APPLICATION NO.	FILING DATE	FIRST NAMED INVENTOR	ATTORNEY DOCKET NO.	CONFIRMATION NO.
09/802,449	03/09/2001	Peter W. Johnson	PJ0101US	7014

Office Action Summary

DETAILED ACTION

Prior Art: Figure 3 of US Patent 6,323,843 to Giles

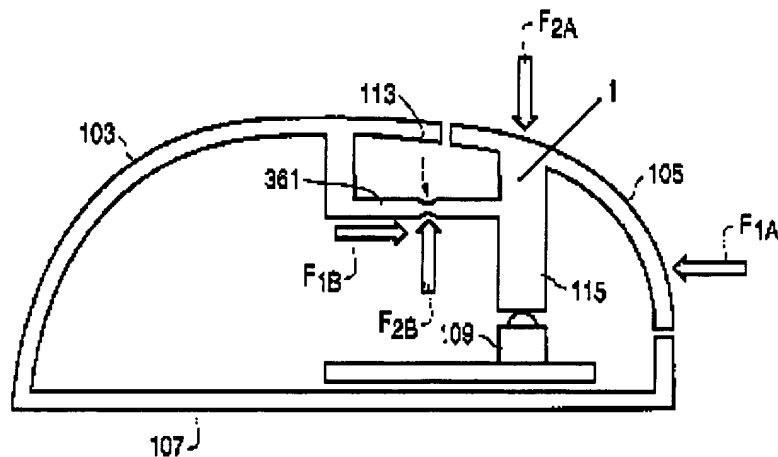
Claims 1-4 rejected under 35 U.S.C. 102(e) as being anticipated by U.S. patent number 6,323,843 to Giles. Giles describes a button assembly that is very similar to the claimed invention. Giles discloses in figure 3 a button assembly comprising a first cantilever beam (361) having a first end and second end, the first end being configured to be attached to an electronic

input device through a first fulcrum (113) at the first end; a second cantilevered beam (105) having an exposed button portion (105), the second cantilevered beam being attached to the first cantilevered beam through a second fulcrum (1). As seen from the figure, the second fulcrum attaches the second cantilevered beam to the first cantilevered beam at the second end of the first cantilevered beam. A plunger (115) attached to the second cantilevered beam and extends from the second cantilevered beam through the first cantilevered beam (361). In column 5, line 7-9, Giles discloses that the button can be constructed from a single piece of molded plastic.

In reference to claim 5, Giles describes a computer pointing input device (Column 1, line 9) in his invention. Referring to figure 3, it is clear that Giles, discloses computer input device comprising a housing (103 and 105) a palm portion of the housing configured to receive a user's hand (103) with a distal portion of the housing extending generally away from the palm portion; a switch button (105) having a palm end (area affected by force F_{1A}) and a distal end (area affected by force F_{2A}) the switch button being configured to actuate an electronic switch (109) within the computer pointing input device upon application of sufficient force to the switch button by the user (F_{1A} , F_{2A} and column 3, lines 23-25), the switch button being movably coupled to the housing so as to move about a fulcrum (1). Giles describes an invention that resembles the claimed invention, however Giles never explicitly stated that the positioning of the fulcrum needed to be nearer to the distal end than the palm end of the switch button. The exact positioning of this fulcrum is a design variable that is not essential to the workings of the invention. There is no disclosed criticality as to require the fulcrum to be positioned in the claimed locality. The position of the fulcrum is a design variable that can be adjusted accordingly by one skilled in the art for the usability of the device.

Claim 9 is dependent on claim 5, and is rejected on the terms similar to the discussion outlined above. In addition, Giles describes a spring beam (361) having a first end and a second end, where the spring beam is coupled to the switch button (105) through the fulcrum (1) at the first end and coupled to the housing at the second end through a second fulcrum (113).

In reference to claim 6 and 10, Giles does describe, a first force applied to the switch button to actuate the electronic switch at the distal end (F_{1A}) and a second force is required to be

Claims 15, 16, 19 and 20 are rejected on the same merits discussed in the rejections of claims 5 and 9 with further understanding that Giles also discloses a plunger (115) coupled to the switch button and extends towards an electronic switch (109), with the plunger configured to actuate the electronic switch upon application of sufficient force to the switch button by the user

(column 3, lines 23-25). Also by referring to figure 3, the plunger extends though the spring beam (361). Finally, as disclosed in Giles (column 1, lines 8-9) his invention is a computer mouse.
